Planning Board AGENDA

Re: Revised Site Plan Review comments- 404 Silver Street Agawam, MA 01001;

**Re: Battery Energy Storage System (BESS), 404 Silver Street, Agawam MA
Response to Comments – Site Plan Review Application**

Proposed Hotel

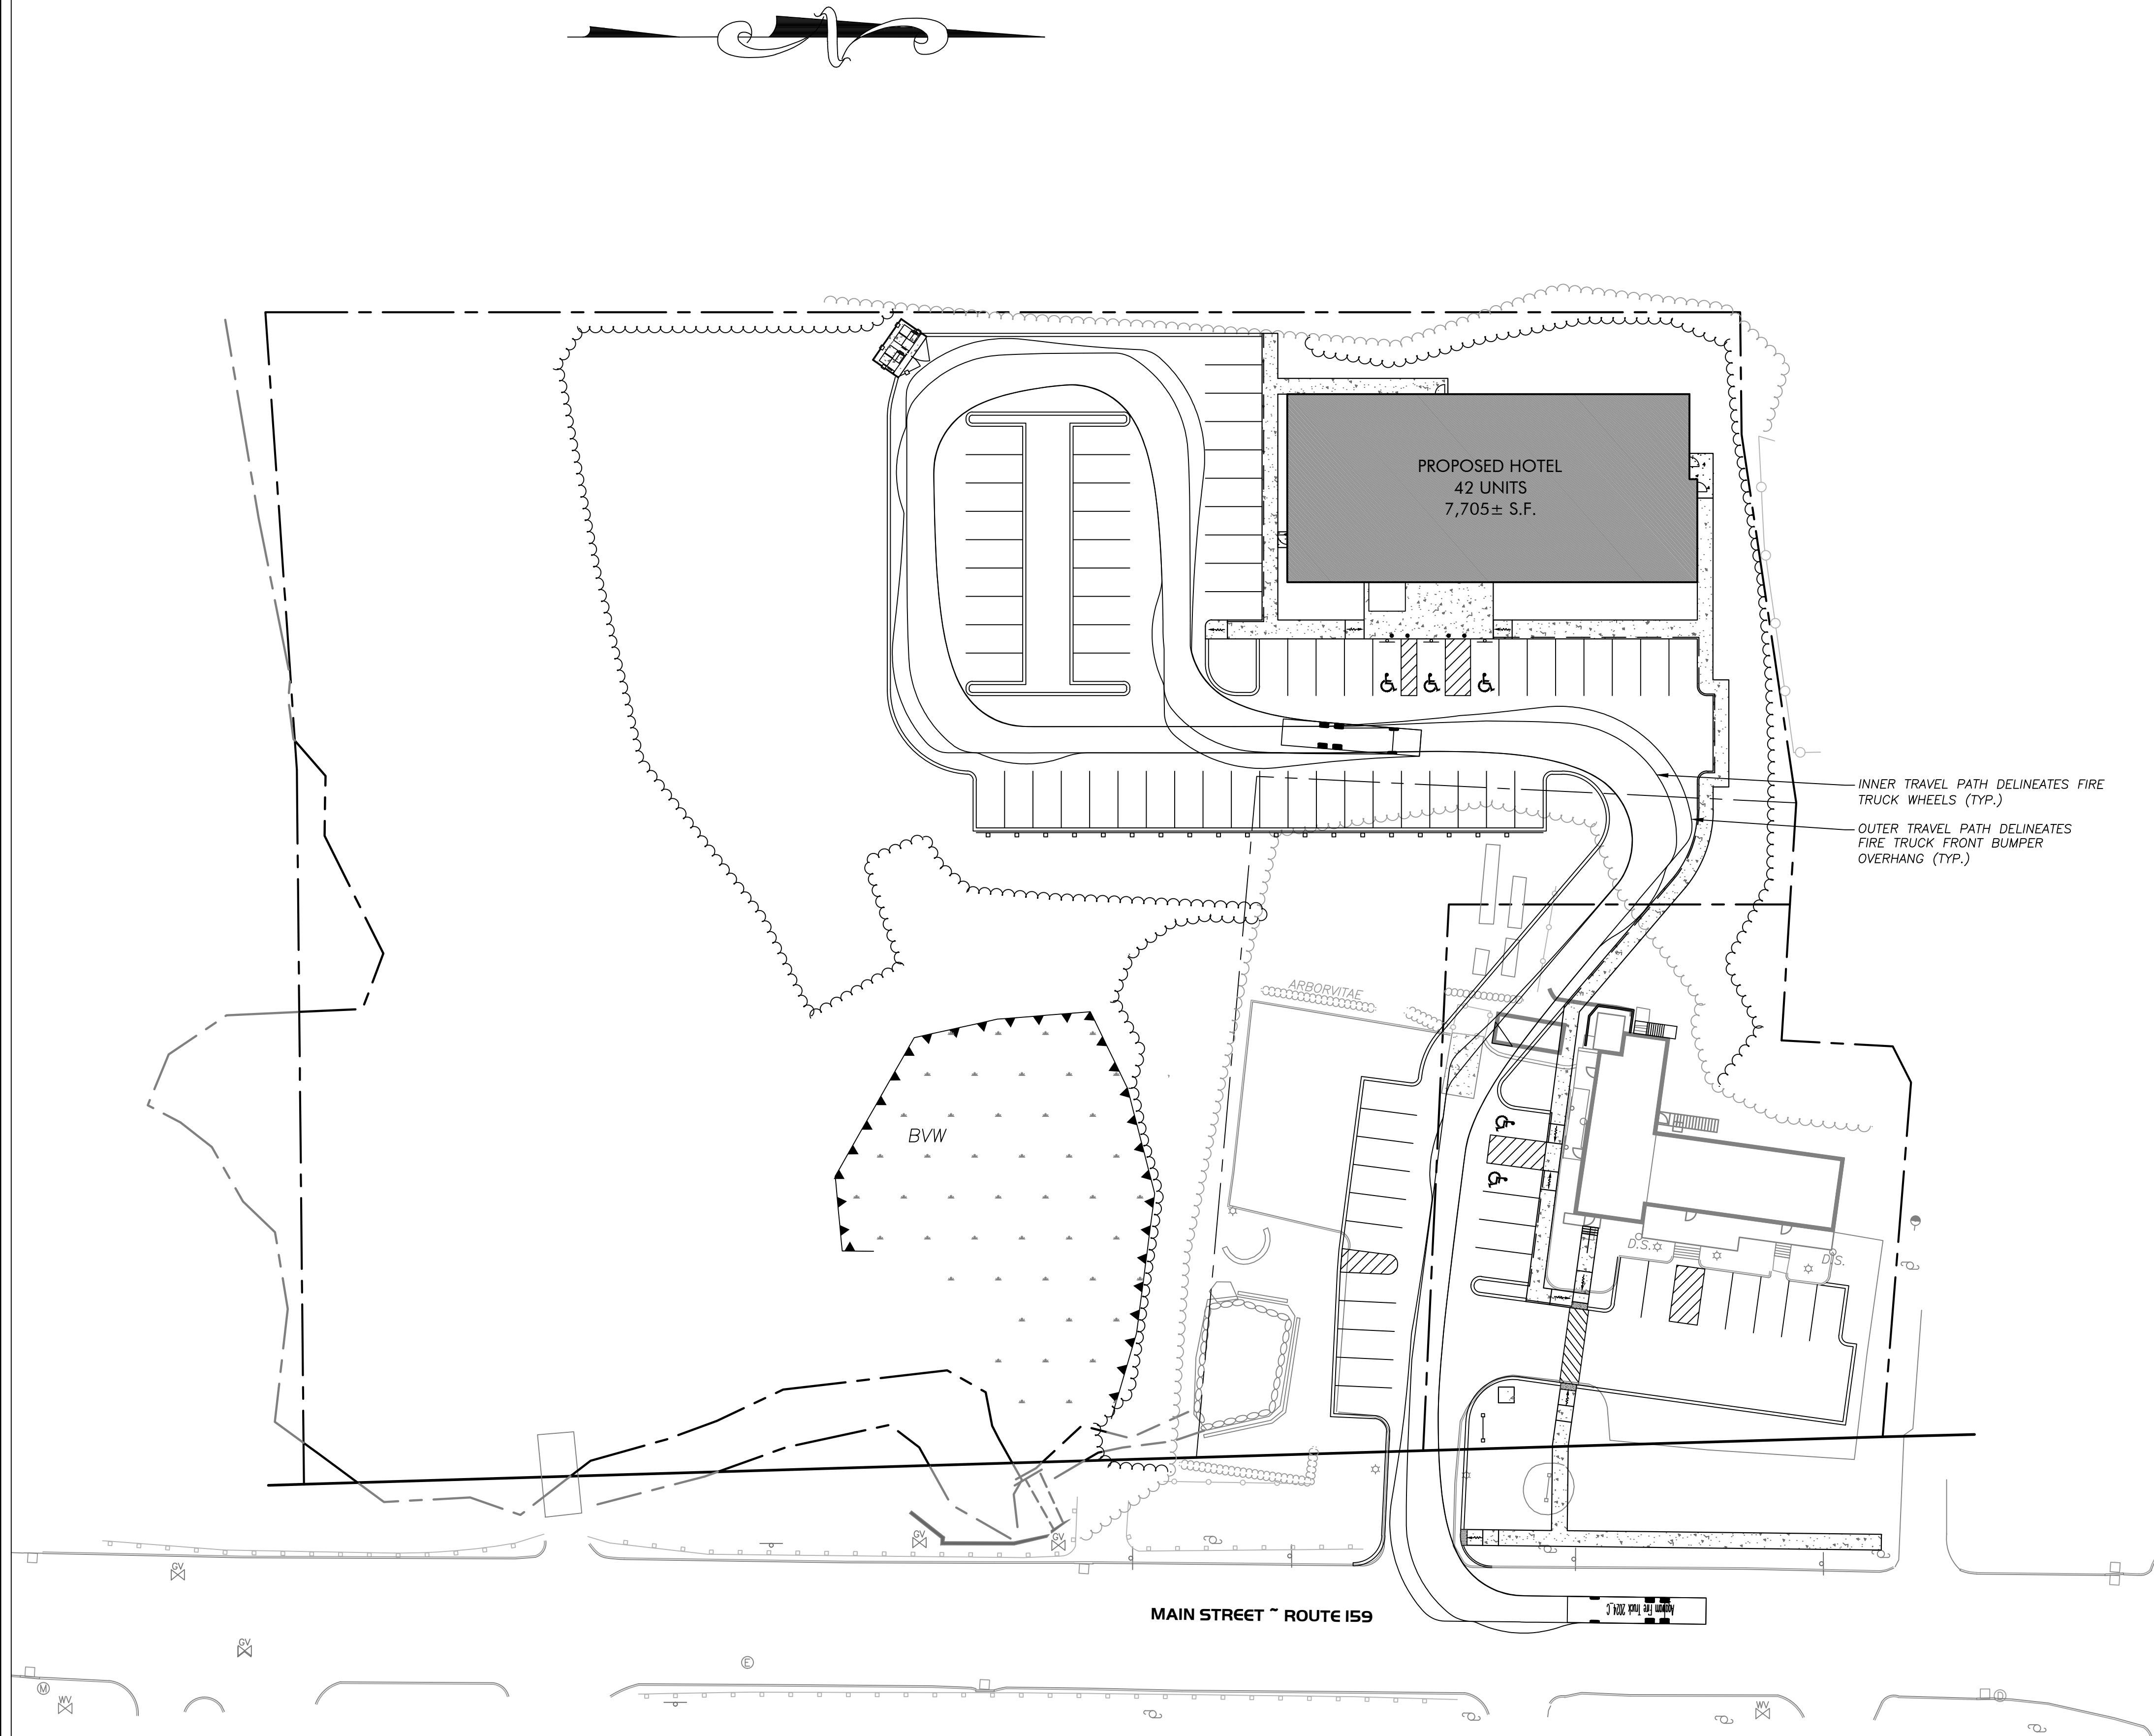
John,
The new swept path plan that was submitted is approved (Drawing# VEH-1...Rev. C)
Thank You
